## **ADDENDUM NO. 4**

Maine Department of Agriculture, Conservation & Forestry  
Cony Road Building Renovation  
333 Cony Road  
Augusta, ME

February 18, 2025

From: WSP USA  
2 Monument Square, Suite 200  
Portland, Maine 04101

**A-101**

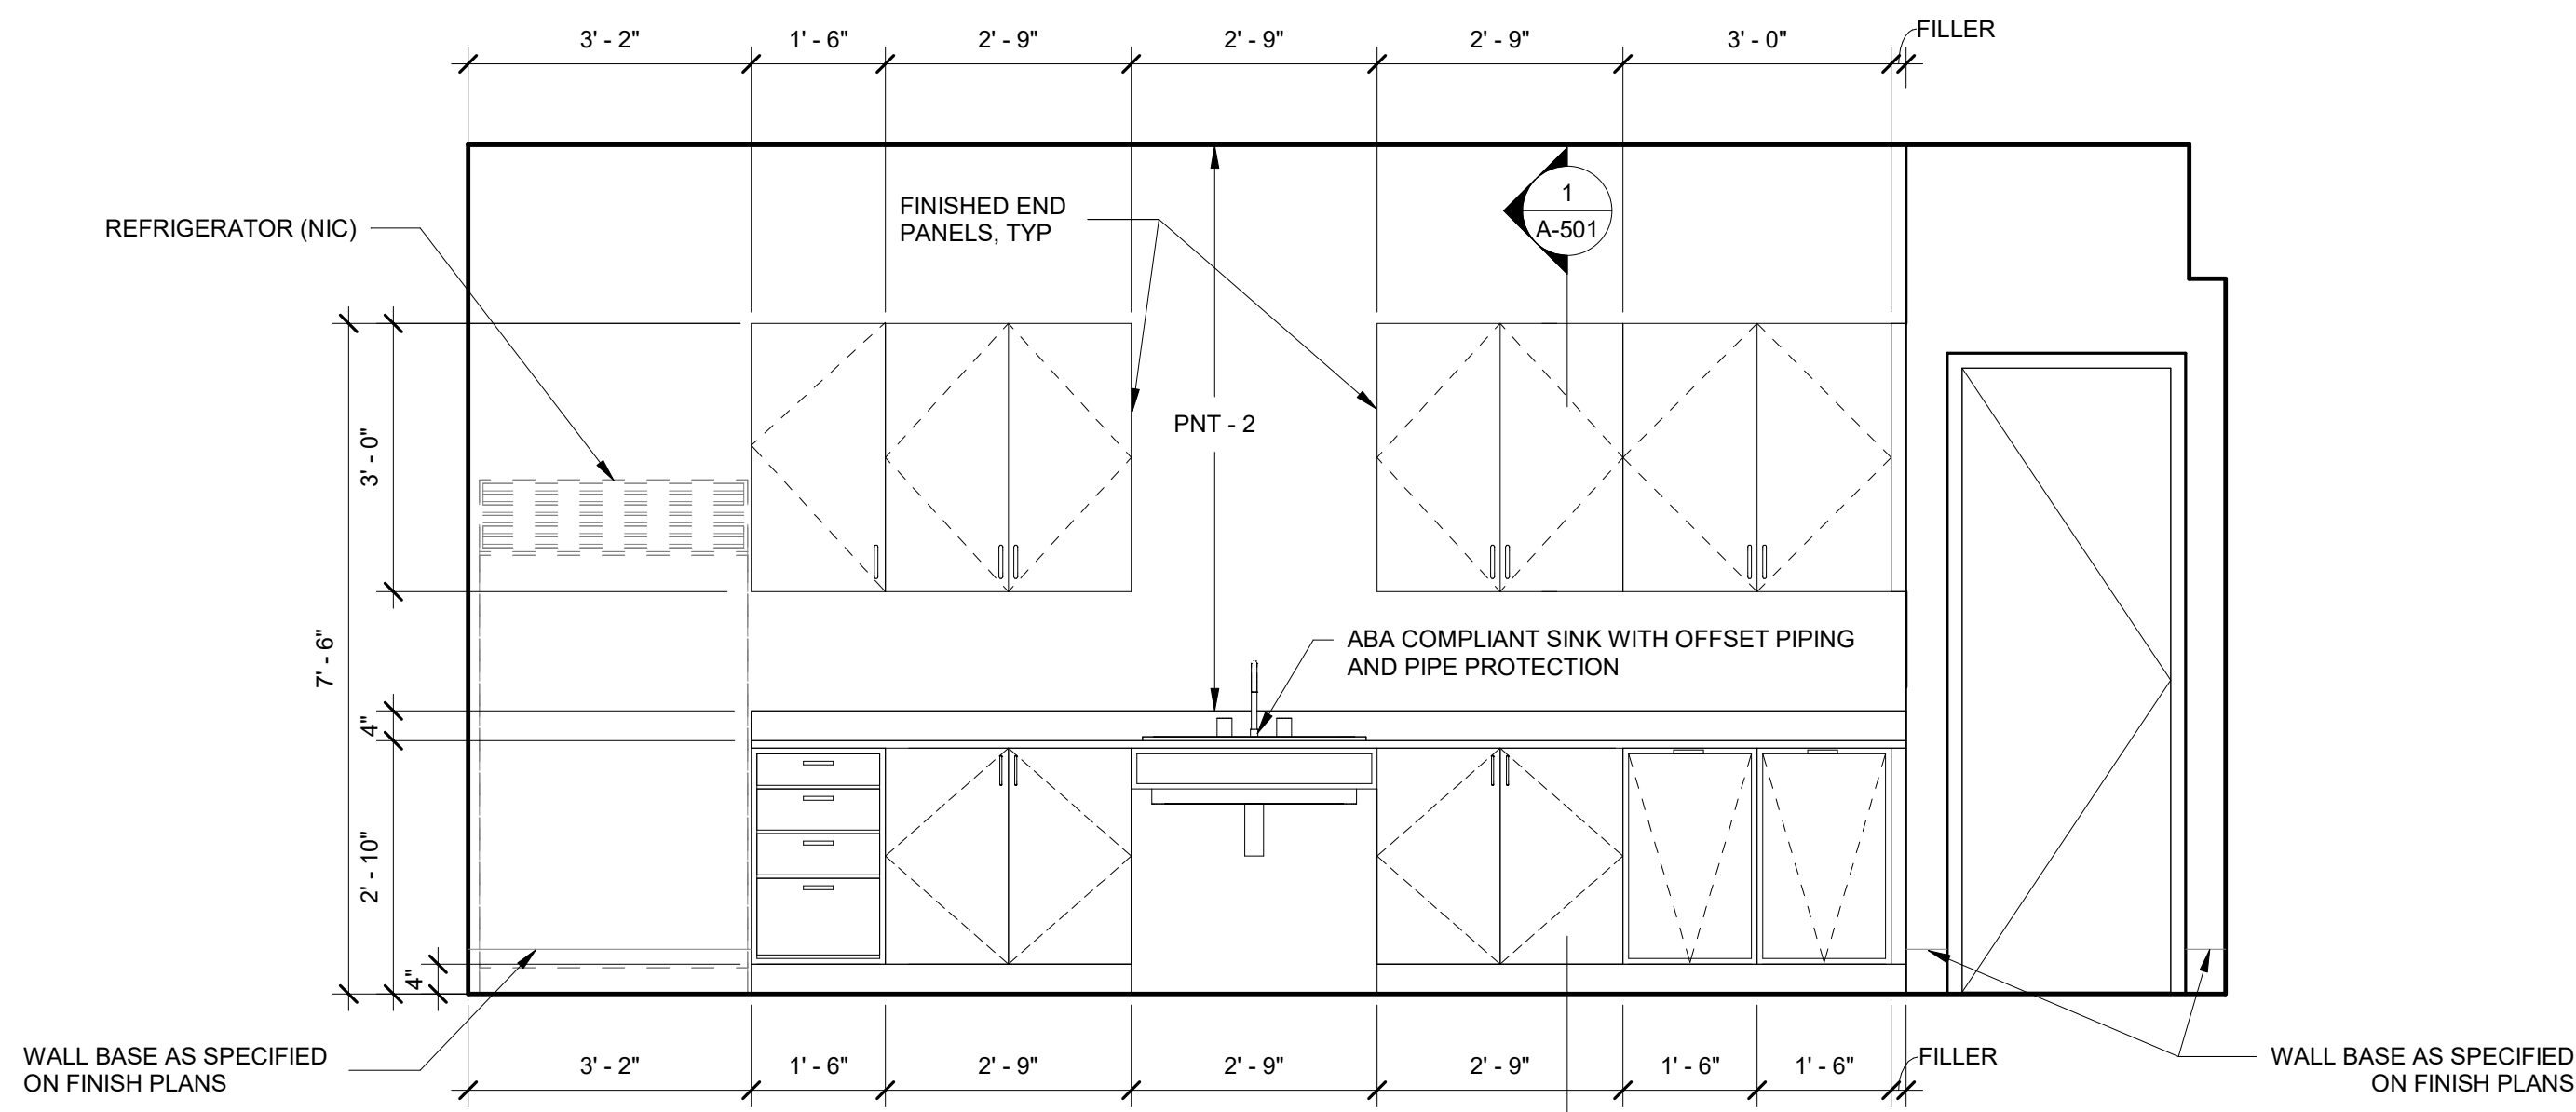
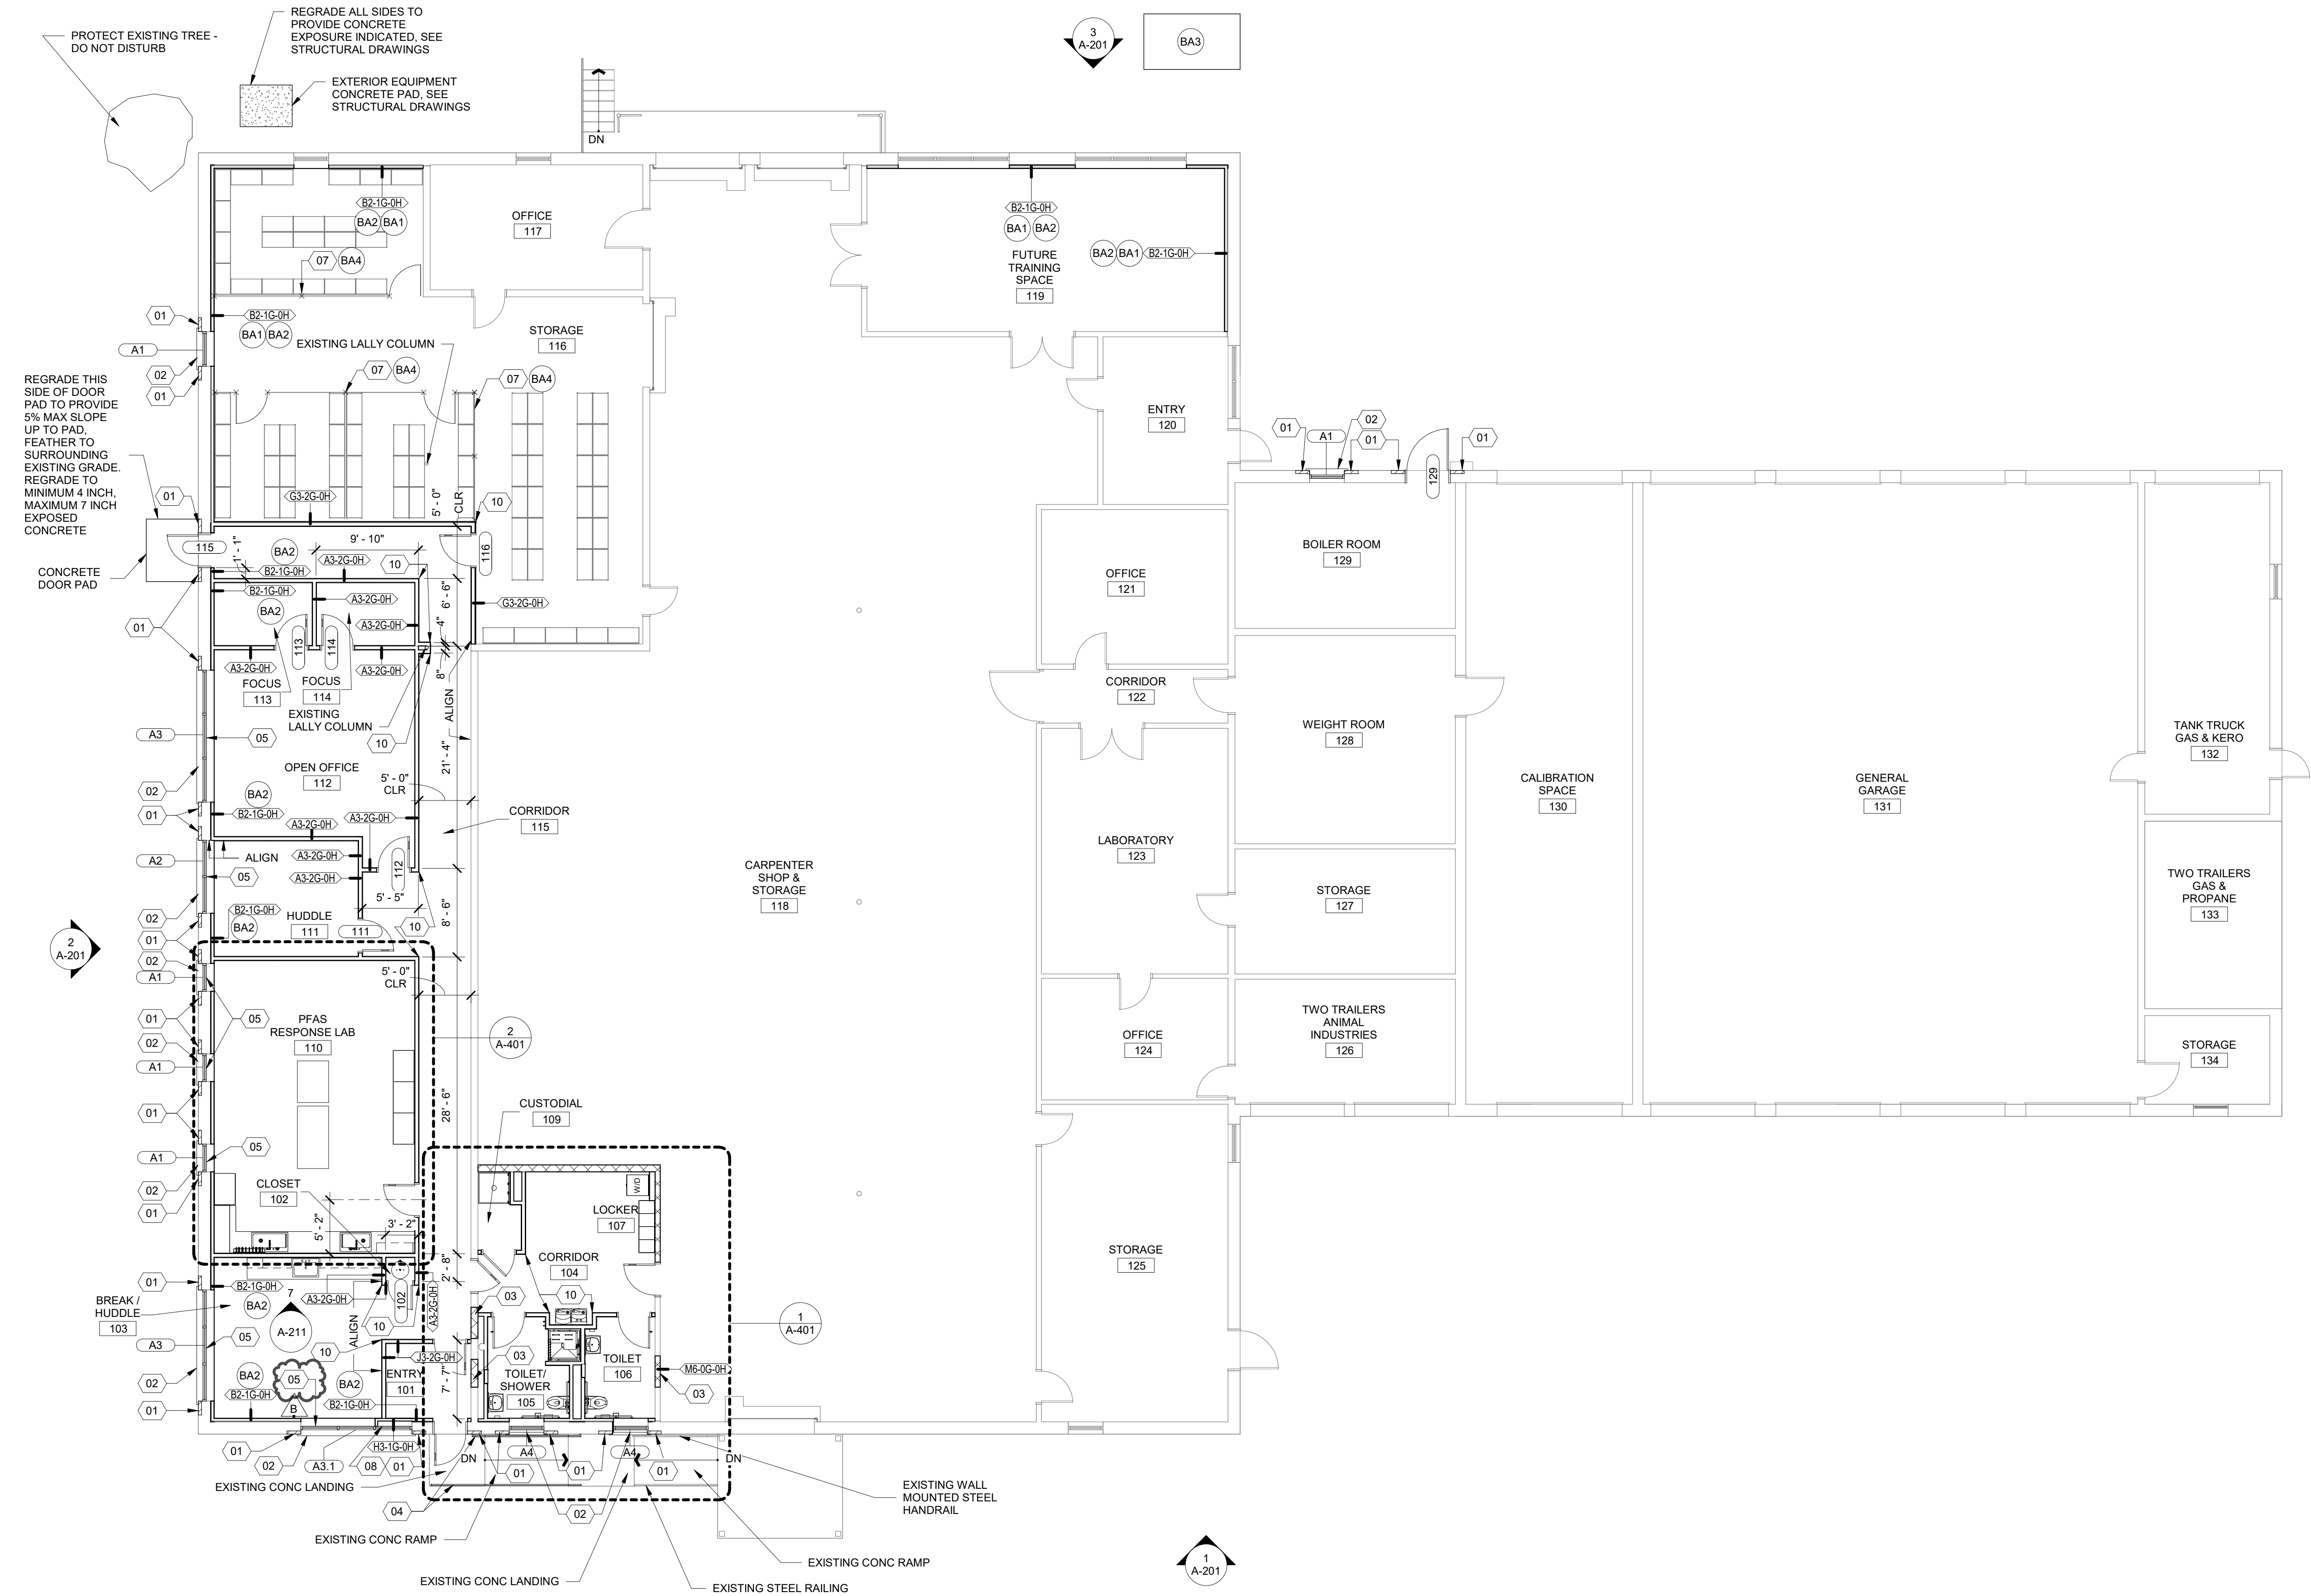
45	2/17/2025	Architectural	Drawing A101 calls for window blinds. Please provide a spec on these.	T McDonald	Basis of design product has been added to A-101	2/17/2025

- WINDOW BLINDS BASIS OF DESIGN - HUNTER DOUGLAS ARCHITECTURAL R8 50+ MANUAL DUAL ROLLER SHADES, OR EQUAL. PROVIDE LIGHT FILTERING FABRIC (M SCREEN DECO 5% OR EQUAL) AND BLACKOUT FABRIC (APOLLO 0% OR EQUAL) WITH SIDE CHANNELS AND FASCIA MATCHING WINDOW FRAME.
